SERVICE BULLETIN

APPLICABILITY: 2015-2017MY Legacy and Outback
SUBJECT: Sticking Secondary Hood Latch

NUMBER: 12-219-17
DATE: 04-10-17

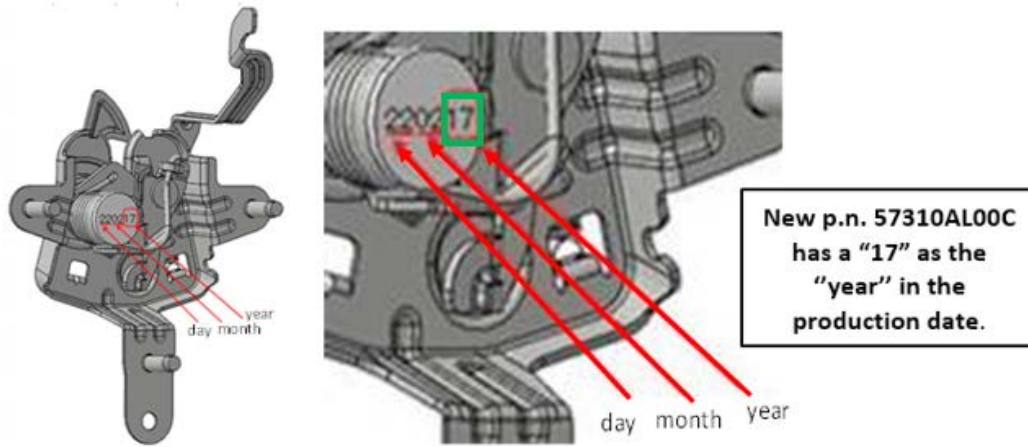
The part number for the new hood latch assembly is **57310AL00C**. If the condition as described above is verified and the VIN is close to the supplied starting VIN, inspect the date code found on the latch as shown below. Latches with the last 2 digits “16” or before require replacement when this condition is identified. Those with “17” as the last 2 digits are the enhanced parts.
